CITY OF ALBUQUERQUE

PLANNING DEPARTMENT – Development Review Services

**RE: Stanford Court (424 Stanford Drive SE)
Grading & Drainage Plan
Engineer's Stamp Date 2-9-16 (File: K16D084)**

GRADING & DRAINAGE PLAN

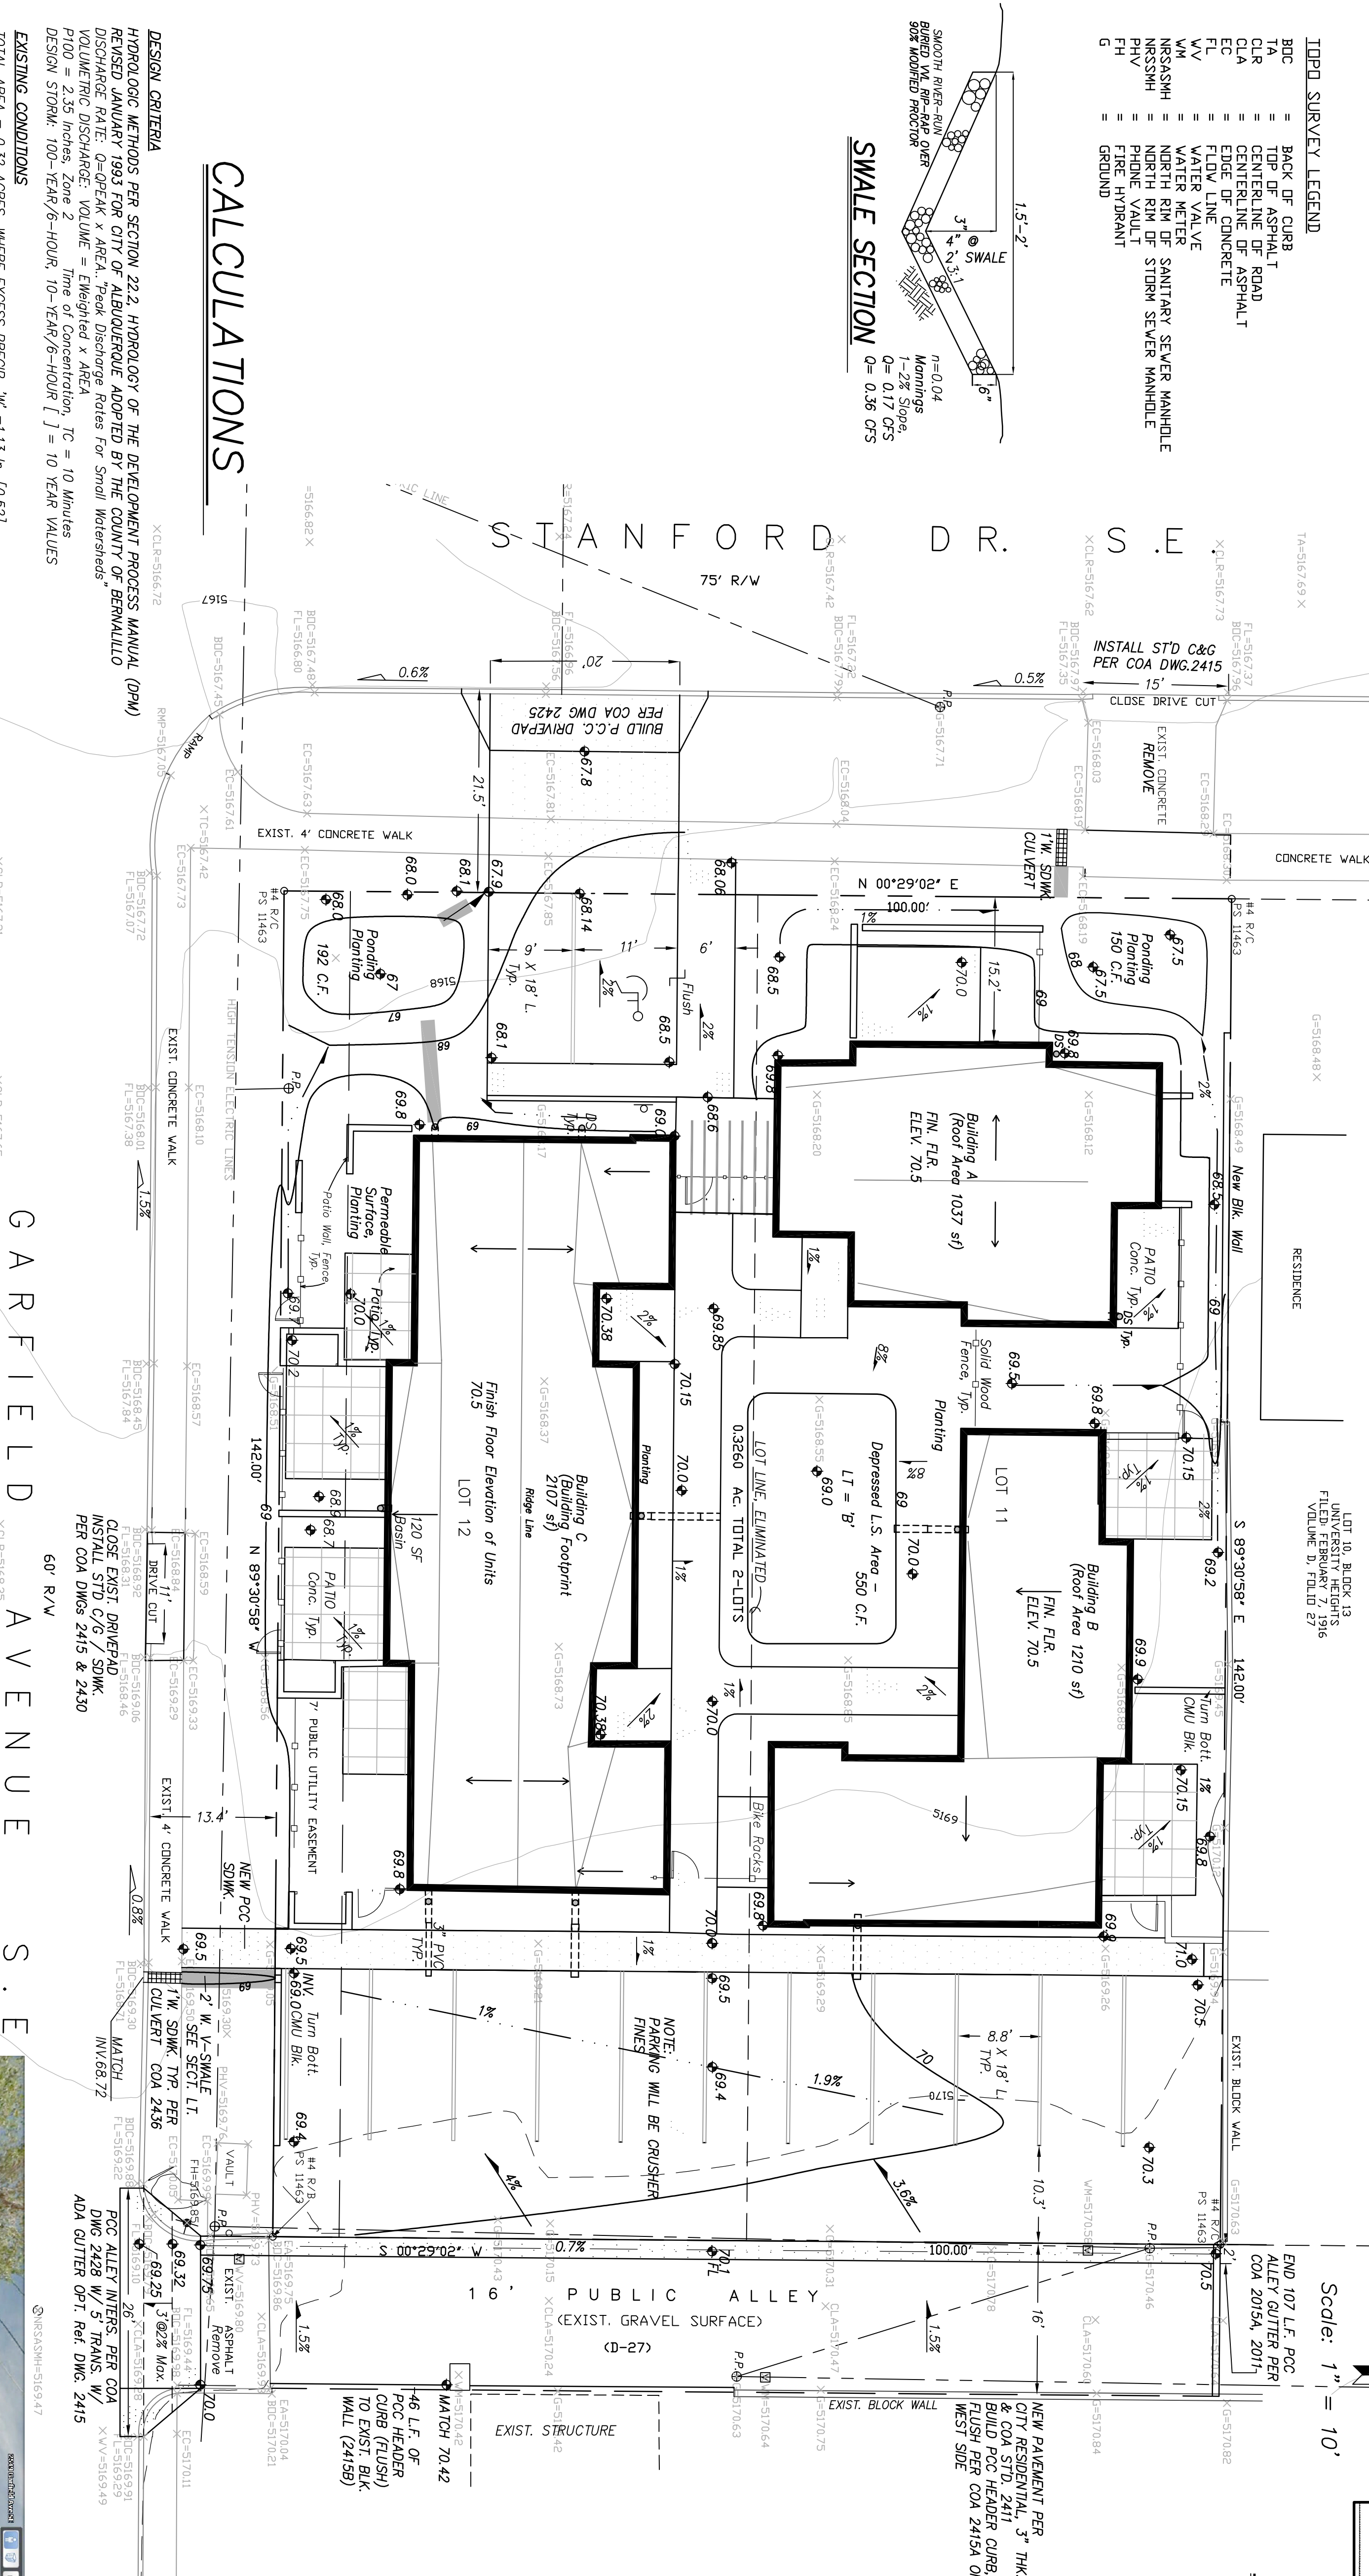
1. That the SO-19 Standard Notes are followed (attached to this letter).
2. That the two sidewalk culverts in City Right of Way are extended 6-inches behind the sidewalk.
